**EXPLANATION OF SIGNIFICANT DIFFERENCES
COMMENCEMENT BAY NEARSHORE/TIDEFLATS SUPERFUND SITE**

August 2000

D. Purpose

Figure 4

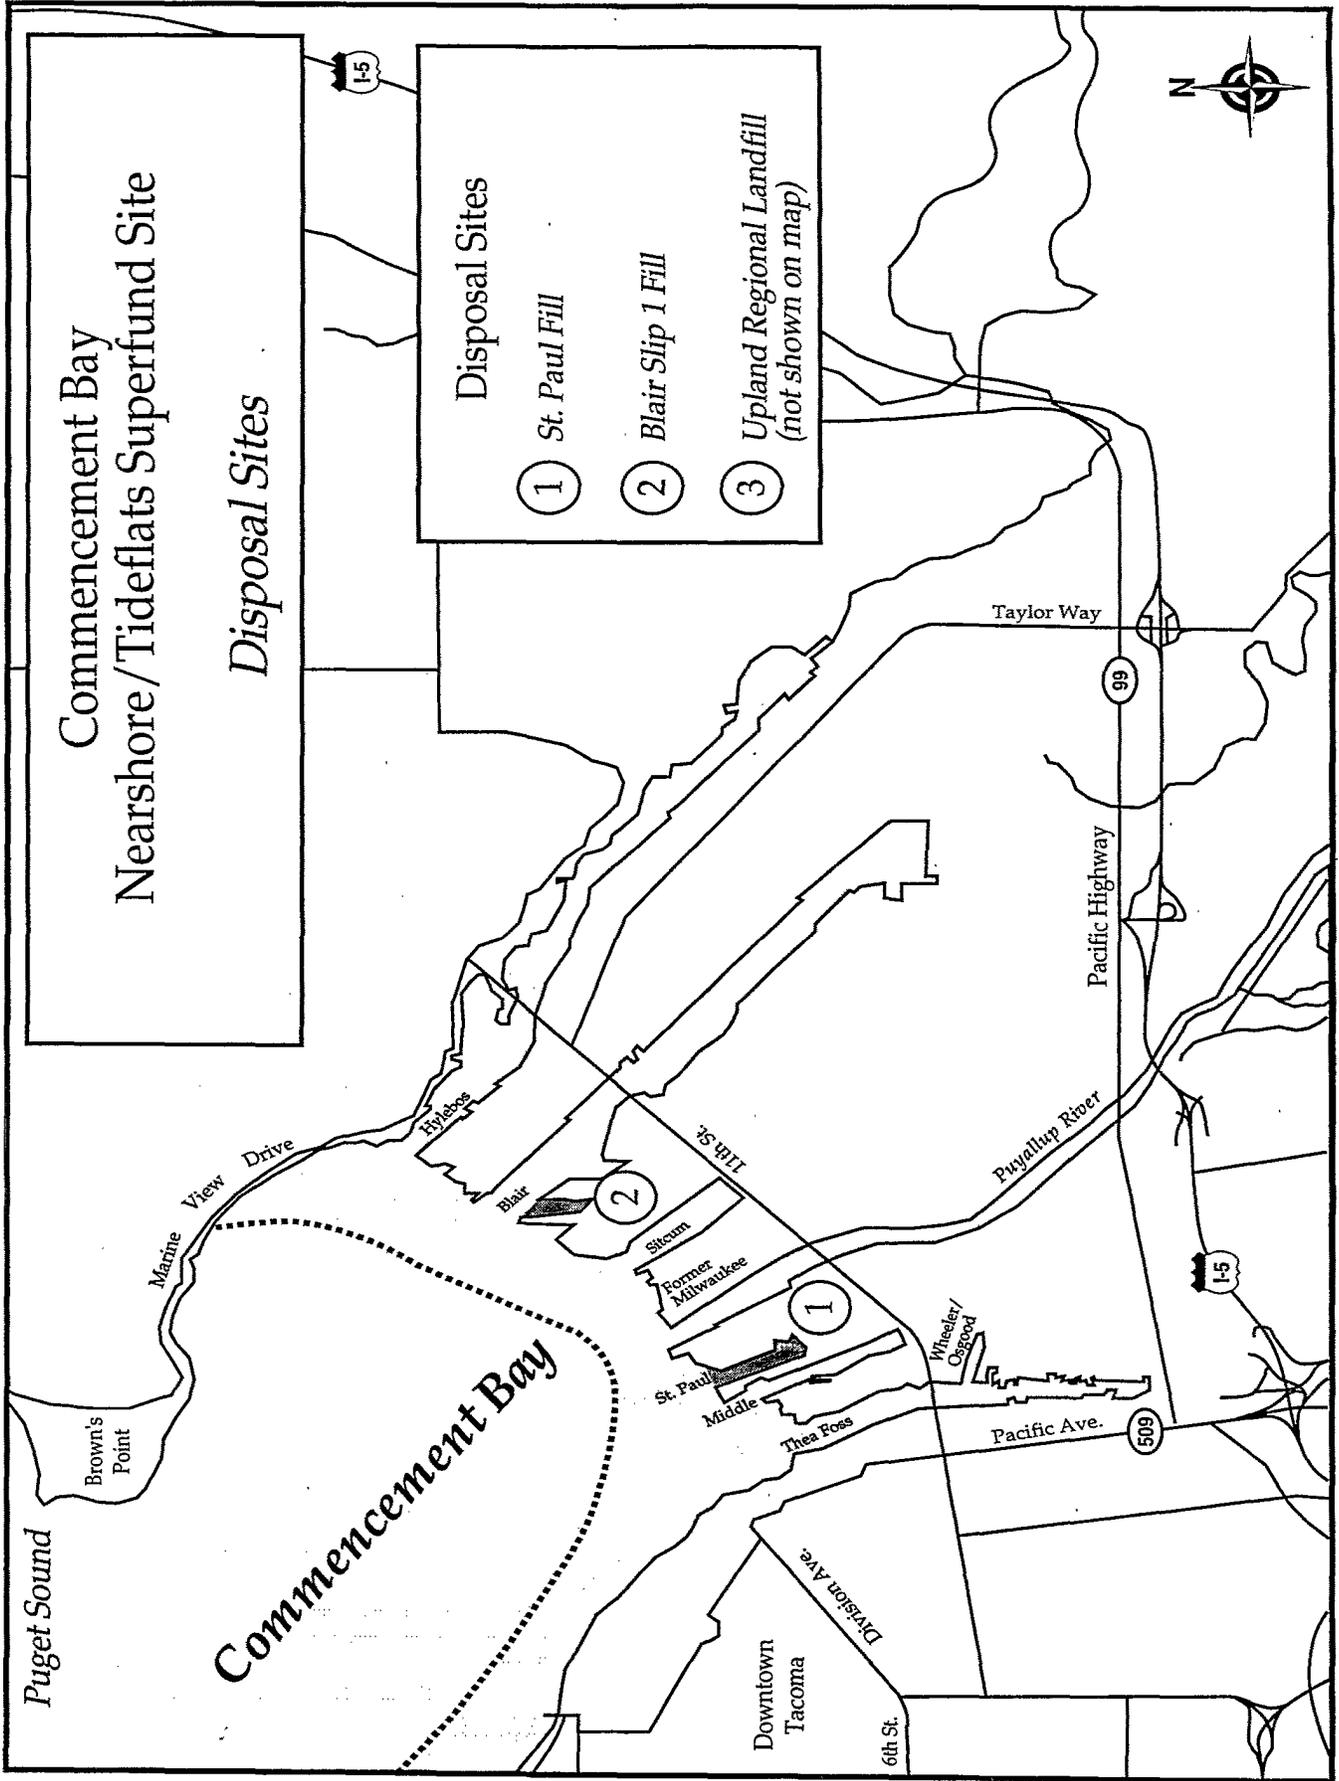
In summary, EPA has selected Blair Slip 1 and the St. Paul Nearshore Fill and disposal at an upland regional landfill as disposal sites to contain contaminated sediments dredged from Hylebos, Thea Foss, Wheeler-Osgood, and Middle Waterways. The location of these disposal sites is shown in Figure 4. EPA will consider an upland on-site fill as an alternative to disposal at an upland regional landfill if it meets the criteria discussed above. More detailed information about the selected disposal sites is provided below.
